File Number: 2-H-25-IH

Meeting: 4/16/2025
Applicant: Dave Madden
Owner: Antares LLC
District: Lonsdale Infill Housing Overlay District

Level III New Primary Structure

Staff recommends approval of Certificate 2-H-25-IH, subject to the following conditions:

LEFT ELEVATION

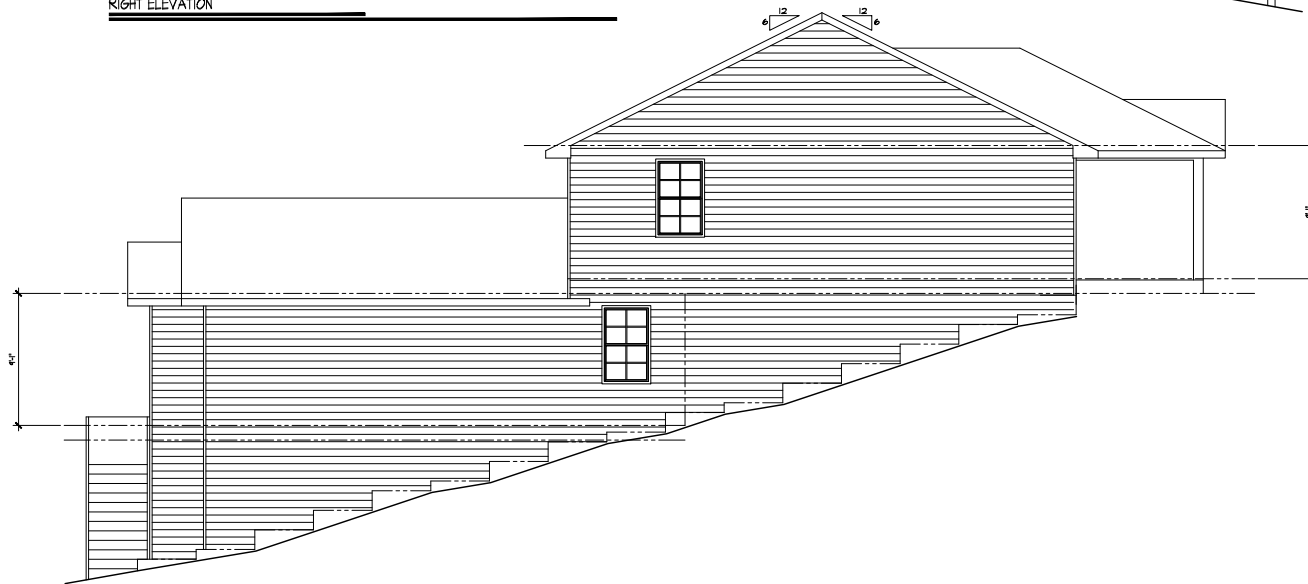
6. Guidelines recommend window and door styles be similar to historic houses on the block, with similar placement and ratio of solid to void. The 4/4 single-hung windows are compatible with the 6/6 single-hung windows on most houses in the block, and all elevations except the left elevation feature a sufficient ratio of solid to void. The left elevation will be minimally visible from the street due to small setbacks, but it features large swaths of blank siding, particularly on the rear massing. The Board should discuss whether an additional window on the left elevation of the rear massing is necessary.

1) the final site plan to meet City Engineering standards; 2) front setback to be revised to align with adjacent new houses, with final measurement provided to staff on final site plan ; 3) parking location to be revised to avoid the front yard; 4) the final site plan to include a walkway to the street; 5) foundation to be clad in stucco or parge-coated and siding to be lap siding with an overlap, as opposed to Dutch lap, flush panel, or board-and-batten siding; 6) the final site plan to include a native or naturalized shade tree in the front yard and rear yard, and the remaining trees in the rear yard should be retained if at all possible.

FRONT ELEVATION

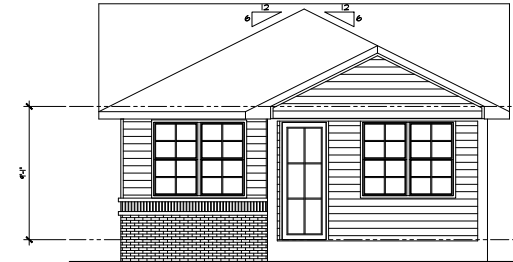
4. The one-story, three-bay façade on the front elevation is similar in scale and height to the context. No other houses on the block feature an additional basement-level massing, but those lots are not steeply sloped.

5. The house features a half-length, 8'-8" deep front porch with a projecting front-gable roof supported by two 8" square wooden posts, which meets design guidelines.
